Amendments to the Drawings:

Applic. No.: 10/631,356 Amdt. Dated February 2, 2006 Reply to Office action of November 2, 2005

REMARKS/ARGUMENTS

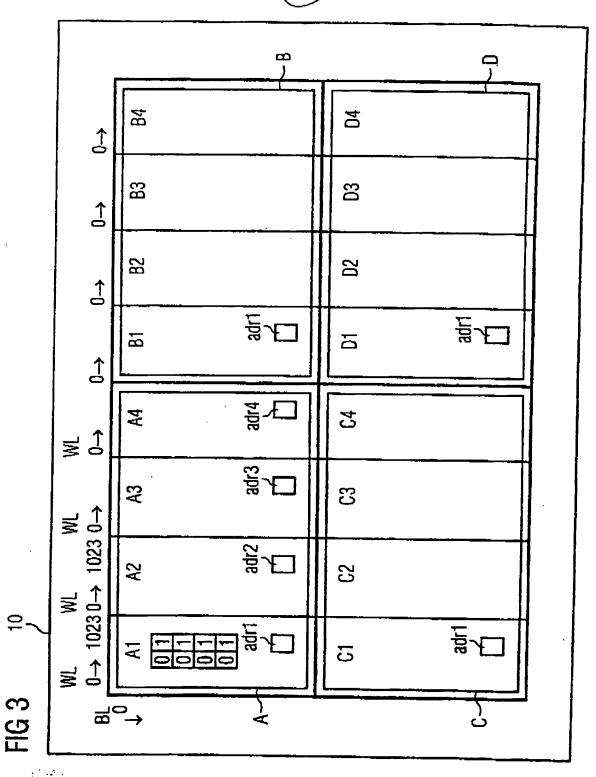
Fig. 6 has been added to show the above-mentioned method steps. The specification has been amended accordingly. Also, it is noted that it is clearly shown in Fig. 3 that a

plurality of subareas (A1, A2, A3, A4; B1, ... B4; ..., D4) are defined in each of the memory banks (A, B, C, D).
